NAS Fallon, Fallon, NV
Contract Number N62473-06-D-2206
Task Order Number 0107

Final Meeting Minutes Remedial Project Manager Meeting

**Conference Room, Environmental Department, Building 307, NAS Fallon, Fallon, NV
Naval Air Station Fallon
Fallon, Nevada**

October 6, 2011

Phase 2 – Treatment of Chlorinated Solvent Plume Adjacent to the E4X Drain

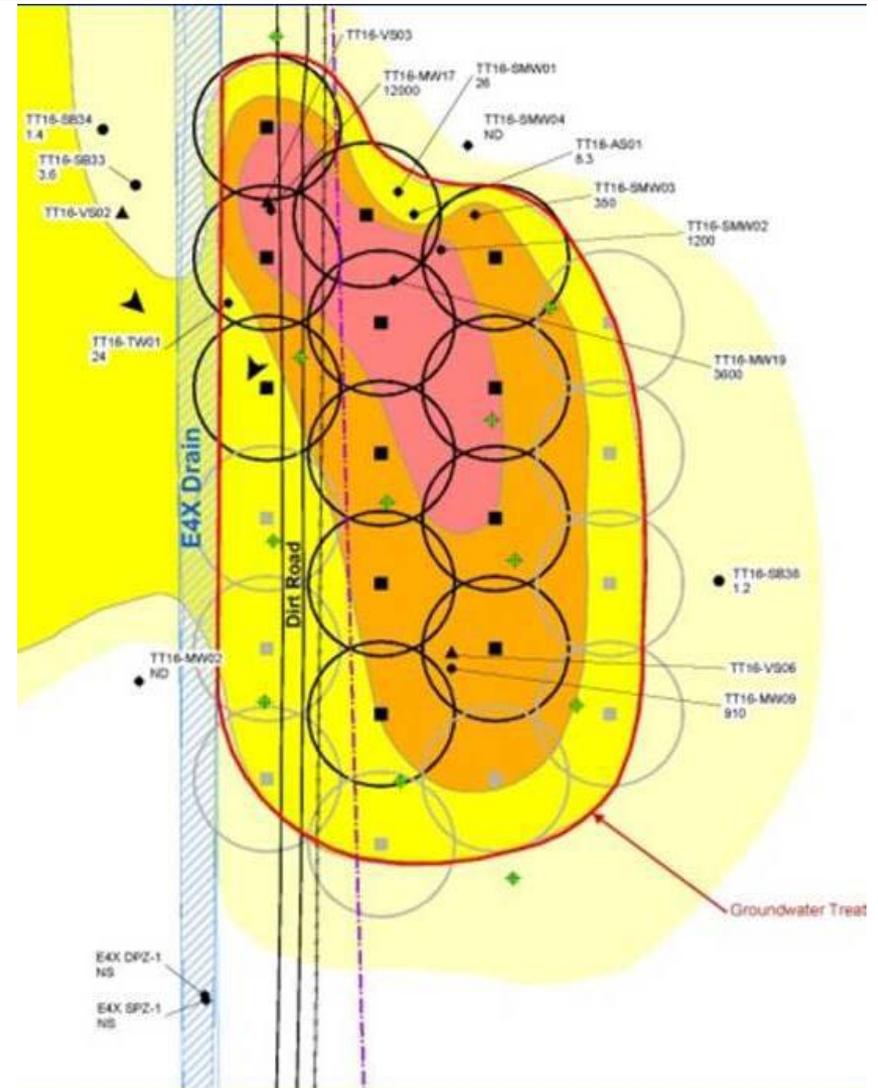
Slide #37: Phase 2 – Treatment of Chlorinated Solvent Plume Adjacent to the E4X Drain – NDEP Comment: What's the depth of the proposed injection of the oxidants?

Navy Response: The proposed oxidants to be injected at the site to oxidize chlorinated solvents are ozone and hydrogen peroxide. The proposed injection depth for ozone is 19 feet bgs, which is just above the groundwater table, and the proposed injection depth for hydrogen peroxide is 13 to 14 feet bgs. The oxidation-reduction potential at the subsurface will be monitored for the first couple months, and then will transition to quarterly groundwater sampling.

Results – 2010/2011 Groundwater Monitoring, Northwest Quadrant

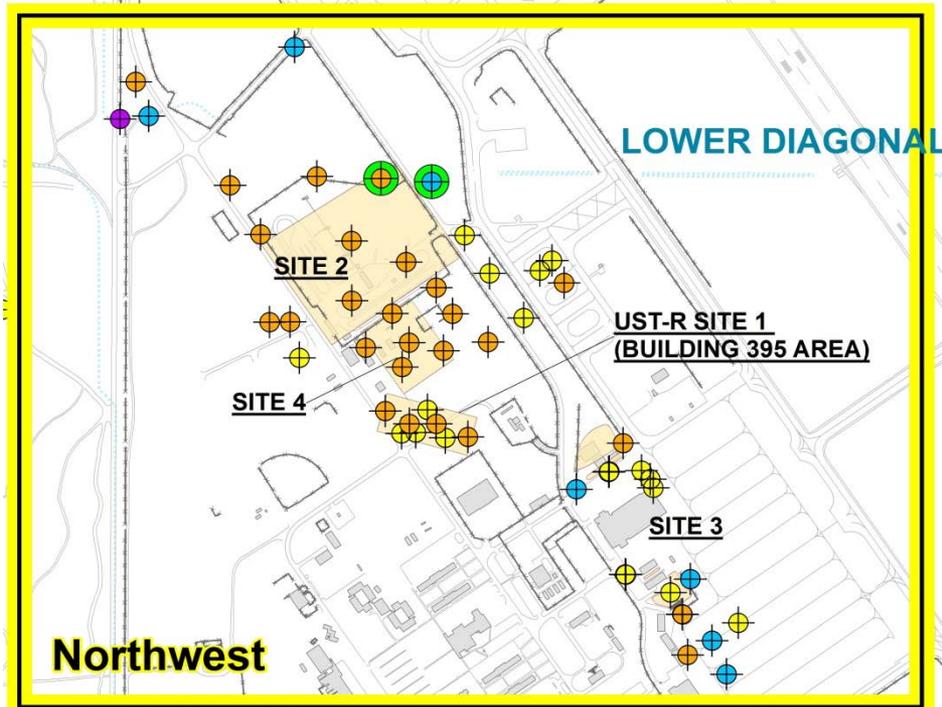
Slide #45: Results of 2010/2011 Basewide Groundwater Monitoring, Northwest Quadrant – Navy

Comment: The basewide groundwater monitoring strategy is dynamic; if a monitoring well is added or dropped from the sampling list, it would be discussed with the NDEP ahead of time.
